DATE: 09/27/2018

APPLIES TO: This service bulletin applies to 2017 through 2019 model year, Gladiator and MetroStar Emergency Response, cabs built between 10/13/2016 and 8/16/2018.

CONDITION: Engine heating conditions may cause a breakdown with the loom associated with wiring inside the righthand side of the engine tunnel.

FIG 3.1

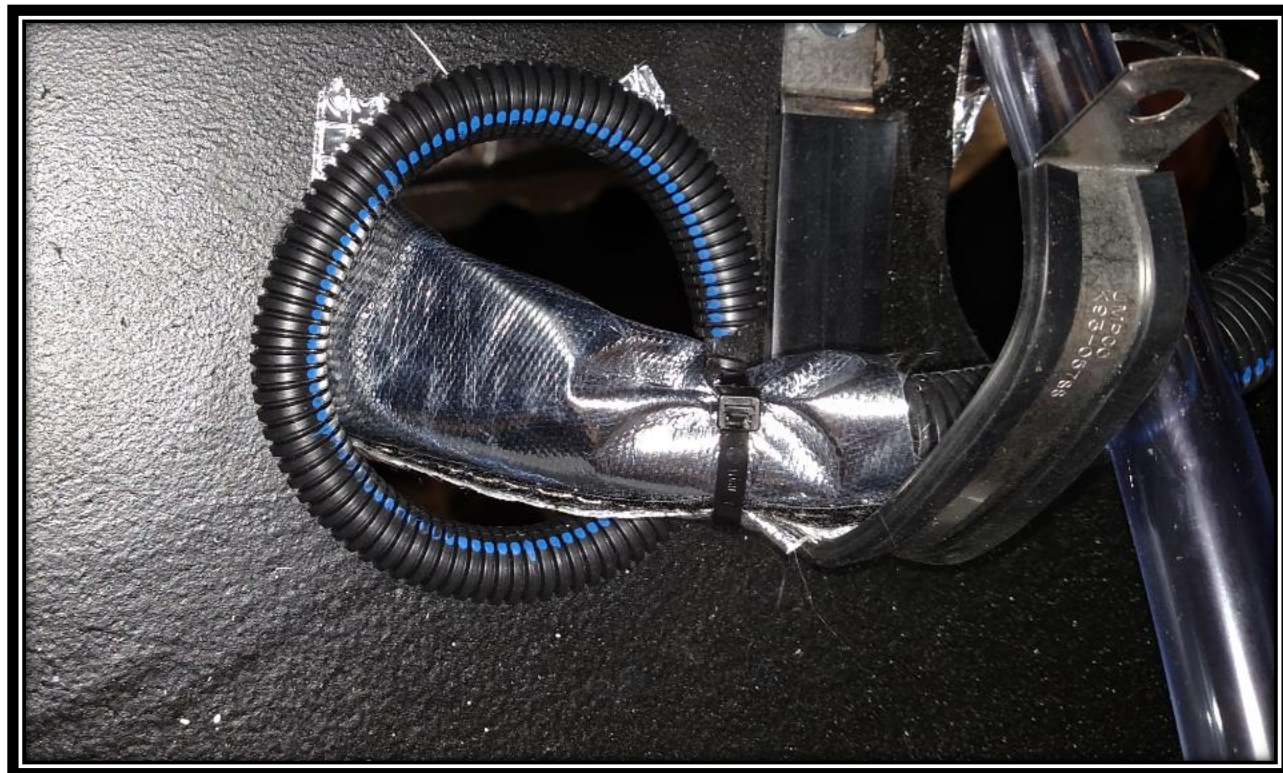
2. Heatshield needs to form around harnessing. Heatshield needs to start outside of engine tunnel as harness enters inside of tunnel. Keep approximately 6" of heatshield outside of engine tunnel. Refer to FIG. 3.1.

FIG 6.1

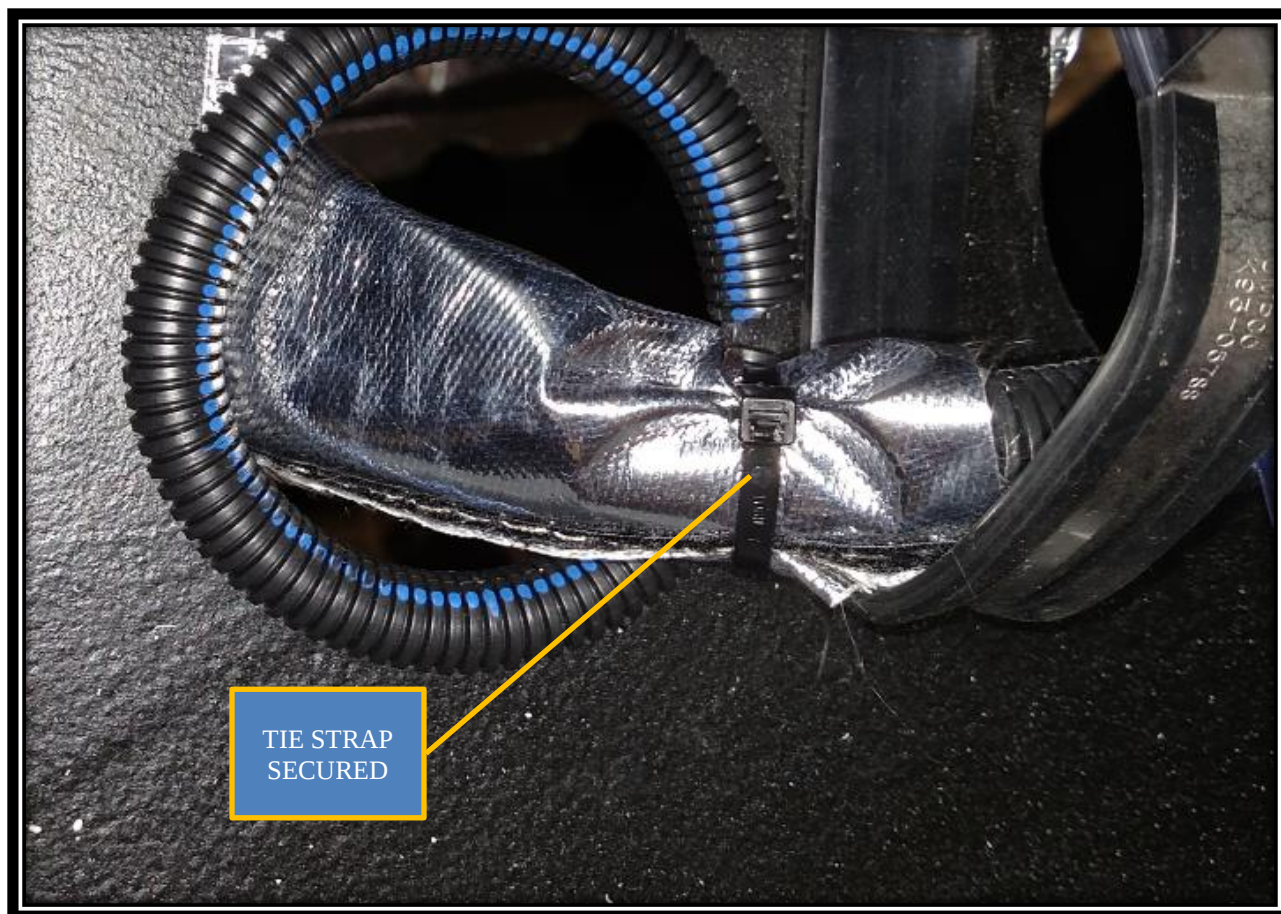
5. Each end of heatshield must be closed using a tie strap. Locate tie strap approximately 1-2" from each end of heatshield and secure. Refer to FIG. 6.1.

FIG 7.1

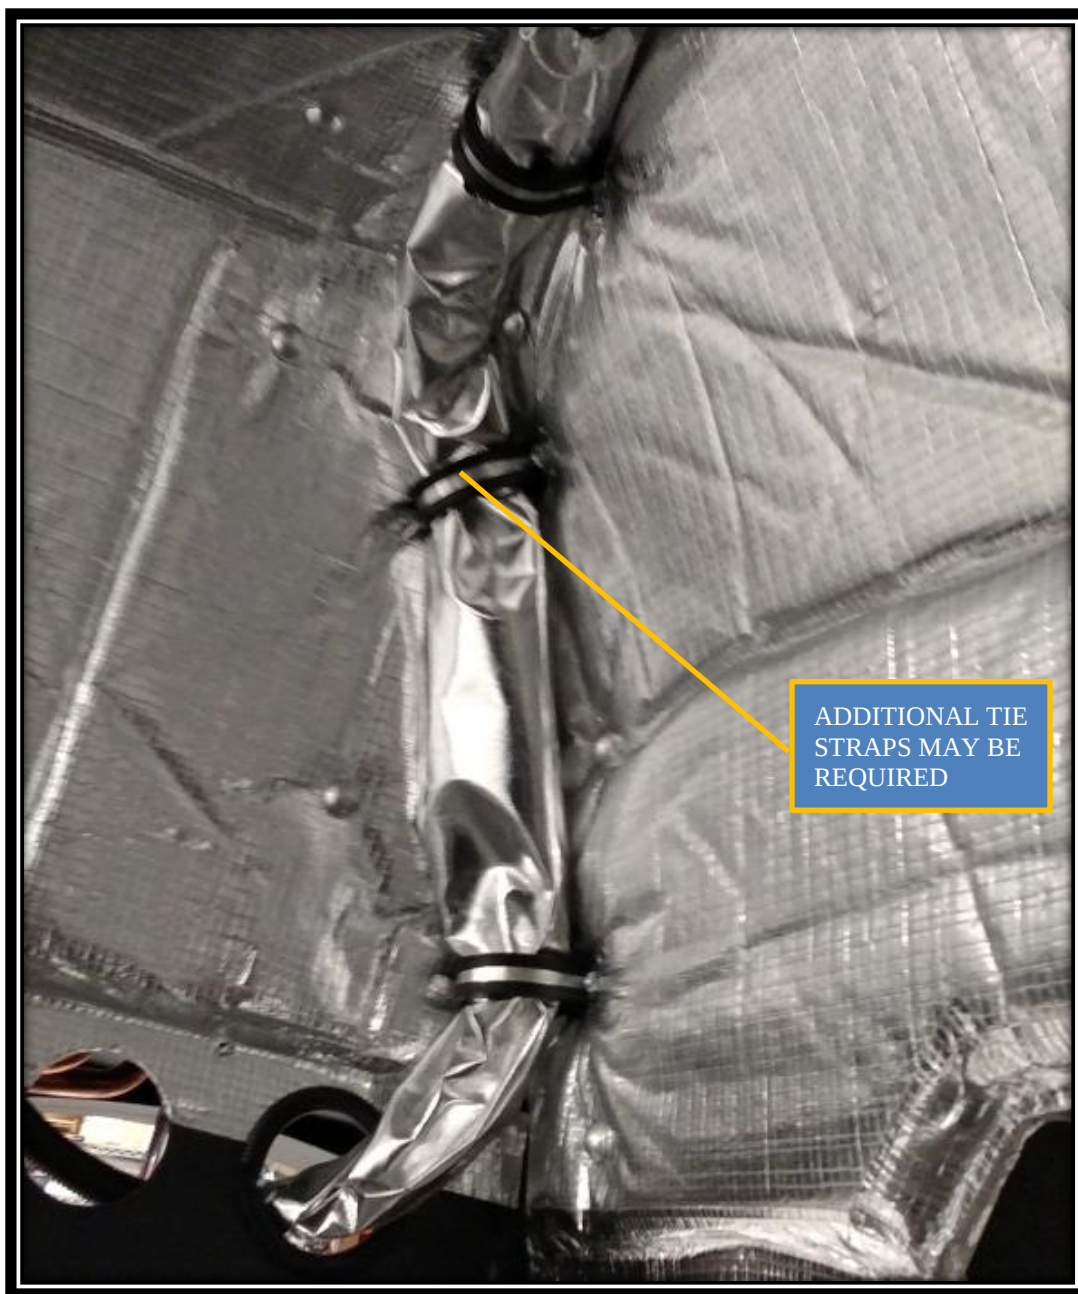
6. Typical installation shown. Additional tie straps may be used to secure smaller harnessing to loop clamps as needed Refer to FIG. 7.1.
